Access Compliance Report Public Rights-of-Way (Curb Ramps)

Main Street: LAMBETH_WAY Cross Street: 17TH_ST Location: SW

ADA ID: RPRK220124110309 Ramp Type: Type 4 - Parallel Initial Pass/Fail: Fail Overall Compliance: No Severity Score: 2

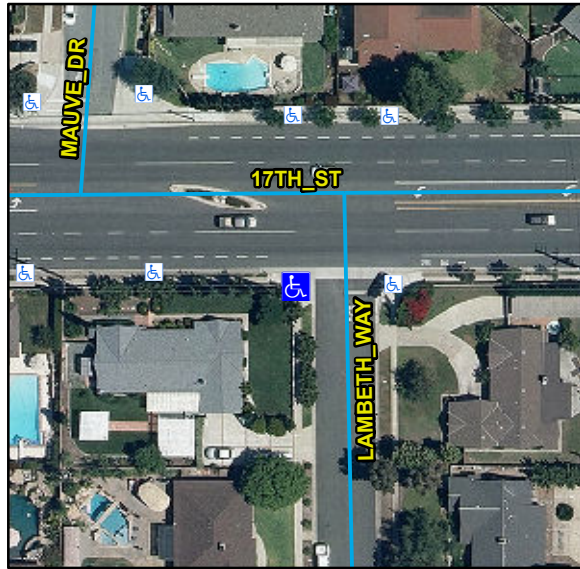
Compliance	Description	Data	Compliance	Description	Data
N/A	Ramp Length LT (in)	89	N/A	Ramp Length RT (in)	74
Yes	Ramp Width LT (in)	101	Yes	Ramp Width RT (in)	100
Yes	Ramp Run Slope LT (%)	5.4	Yes	Ramp Run Slope RT (%)	3.9
Yes	Ramp Cross Slope LT (%)	1.2	No	Ramp Cross Slope RT (%)	4.9
N/A	Landing Present	N/A	N/A	DWS Provided	N/A
N/A	Landing Length (in)	N/A	N/A	DWS Contrast	N/A
N/A	Landing Width (in)	N/A	N/A	DWS Length (in)	N/A
N/A	Landing Run Slope (%)	N/A	N/A	DWS Full Width	N/A
N/A	Landing Cross Slope (%)	N/A		DWS Offset Type	N/A
N/A	Landing Movement Obstructed?	N/A	N/A	DWS Offset Left (in)	N/A
	Landing Movement Type	N/A	N/A	DWS Offset Right (in)	N/A
N/A	Landing Shared	N/A			
N/A	Clear Space	Yes			
N/A	Clear Space To Crosswalk (in)	N/A			
N/A	Marked Crosswalk 1	No	N/A	Marked Crosswalk 2	No
	Crossing 1 Direction	E		Crossing 2 Direction	N
	Marked Crosswalk 1 Width (in)	N/A		Marked Crosswalk 2 Width (in)	N/A

Remove & Replace Curb Ramp With Two New Directional Ramps or Equivalent.
